**16850 Stepler Road**  
**Traffic Study Letter**  
PCD File No.

El Paso County, Colorado

This letter documents the results of a traffic study including trip generation, trip distribution, traffic assignment, and intersection analysis for the proposed 16850 Steppler Road single family development along Settlers Ranch Road to the north of Hodgen Road in El Paso County, Colorado. A road impact fee assessment as well as a sight distance evaluation are also both included in this traffic study. This traffic study supports a rezoning effort for the 36.2-acre parcel which has the potential to include approximately 14 single-family homes, each on approximately 2.5-acre lots. No subdivision plat is proposed at this stage. Of note, most of the single-family homes in the surrounding area are also on 2.5-acre lots. A vicinity map is attached in **Figure 1**. A conceptual site plan for the project is attached.

Hodgen Road & Timber Meadow Drive (#1)

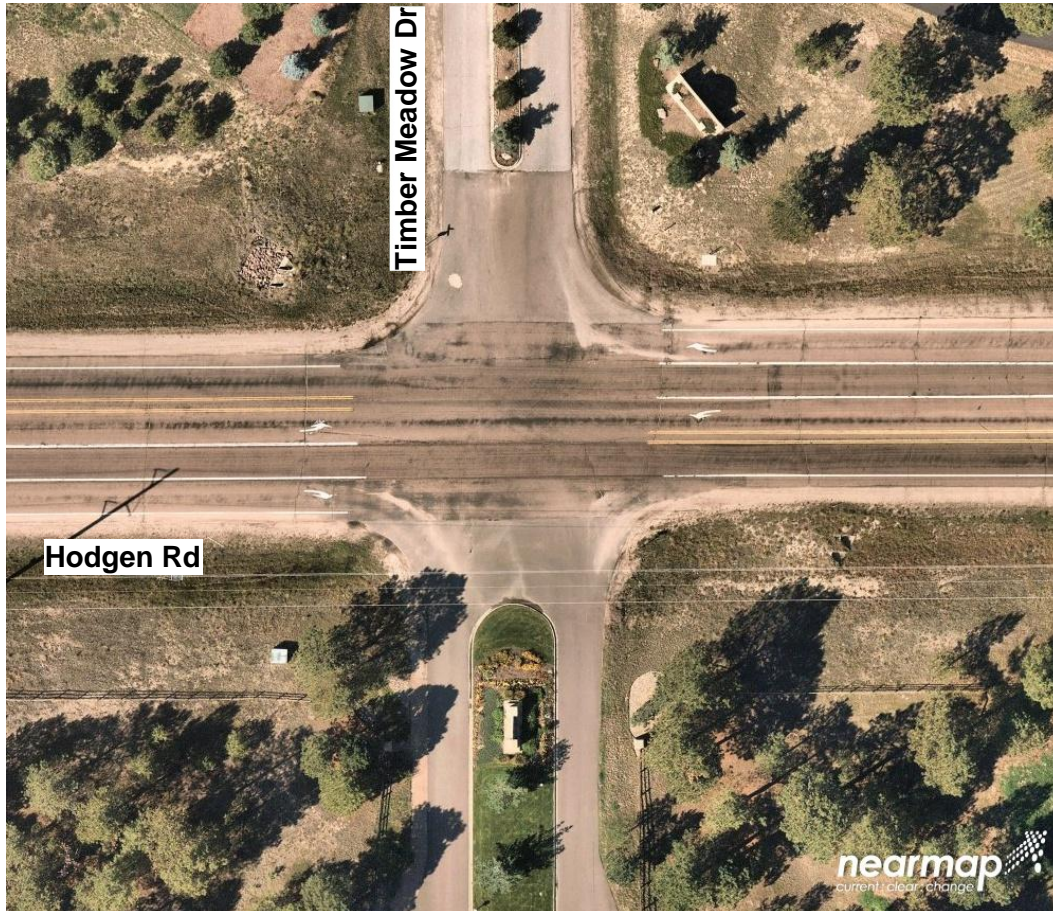
Please indicate what your background values account for besides the annual growth as it does not appear to account for the most current approved phase of the settler ranch subdivision Filing 2C (PCD File SF1818). Filing 2C added 11 lots to the existing 14 lots along Settlers Ranch Rd.

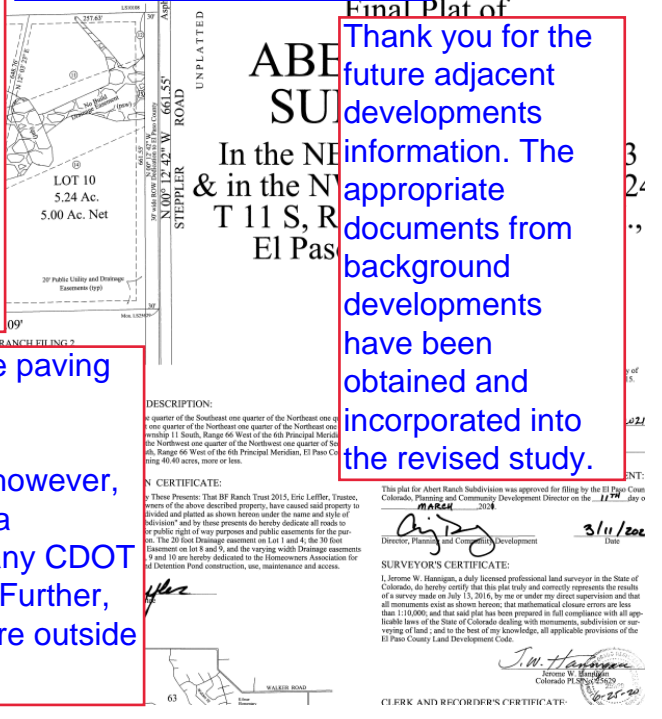
-Please list any previous studies in the area (i.e. Abert Ranch, Settlers Ranch, Settlers View)

-Provide analysis of turn lane requirements at Timber Meadows and Hodgen. Per the total traffic volumes (figure 7) it appears that the threshold for a southbound dedicated right turn lane on Timber Meadows is met. Provide recommendations whether a dedicated right turn lane should be installed or if the queuing and widen radius that was allowed in the first fillings of Settlers ranch is sufficient. (previous TIS from Settlers Ranch will be uploaded onto EDARP for your use. See page 2 #7)

-With the addition of these 14 lots, the code maximum of 25 lots on a dead end road will be exceeded therefore a secondary access will be needed. Please discuss where the secondary access will be obtained. FYI: Abert Ranch worked with Settlers Ranch by providing a secondary emergency access through Settlers Ranch Rd to Stepler Rd from Abert Ranch Drive to the east. Consider working with Settlers Ranch to extend the gravel cul-de-sac to Abert Ranch Drive.

Adjacent development traffic studies have been listed in the revised study.

An evaluation has been provided for the potential need for a southbound right turn lane at the Timbers Meadow and Hodgen intersection. The pertinent information from page 2 of the original 2004 Settlers Ranch Traffic Memorandum has been documented in the study.

The need for a secondary access point has been discussed and evaluated in the traffic memorandum.

**FIGURE 4**  
 16850 STEPLER ROAD  
 EL PASO COUNTY, COLORADO  
 2026 BACKGROUND TRAFFIC VOLUMES

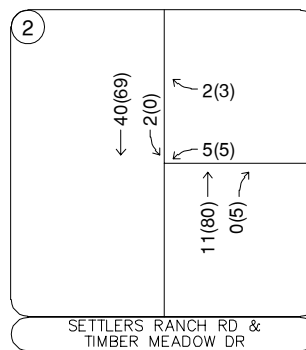
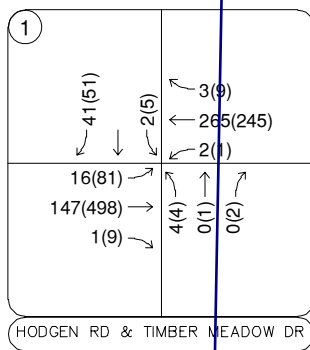
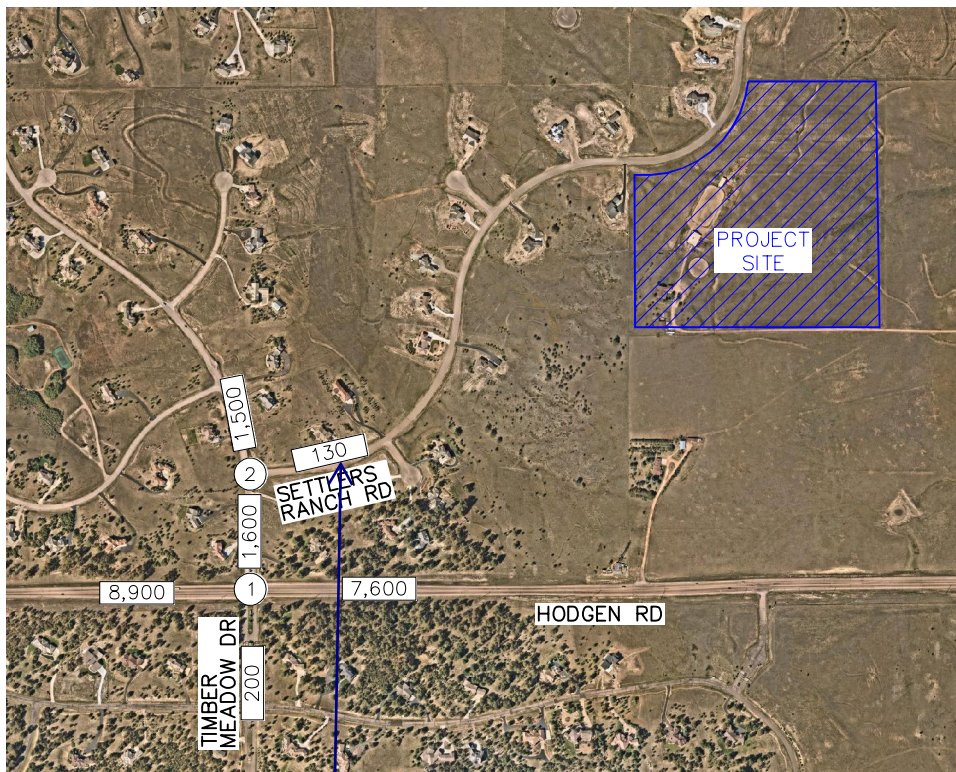
See comment on page 5 and adjust your analysis accordingly.

ADT updated to include future adjacent development traffic.
